SERVICE LETTER 164 PAGE 1 of 3 REV: A

SERVICE LETTER NUMBER 164			
TITLE: 8750 Power Pack O-ring replacement			
BY: C.Schlemmer	AIRCRAFT MAKE/MODEL(S):	FLOAT MODEL(S):	NOTE(S):
APP: J.Sortor			Optional Compliance
DATE: 10/26/15	CESSNA 208 and 208B	8750	S/L P/N 1008736
REV: A			ECO-24391

TECHNICAL DATA:

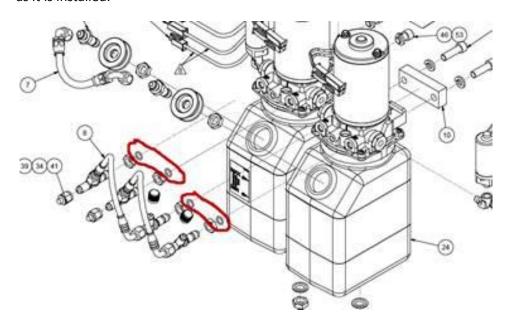
On extended flights some power packs have experienced hydraulic fluid leaking from the T.

Replace all four O-rings MS28775-012 with O-ring MS28778-4

- 1. Secure airplane safely before following the procedures for replacing O-rings.
- 2. Place plane under a hoist or position so plane can be placed on jack stands.
- 3. Remove fairings to expose lifting points.
- 4. Safely relieve all pressure in the power pack. Prior to removing fittings.
- 5. Remove the hydraulic lines going to the first T and then back the lock nut off so the T can be removed
- 6. Remove the O-ring and carefully install the new one, making sure not to damage the O-ring as it is installed.

- 7. Reinstall the T and hydraulic lines.
- 8. Repeat process for remaining T's
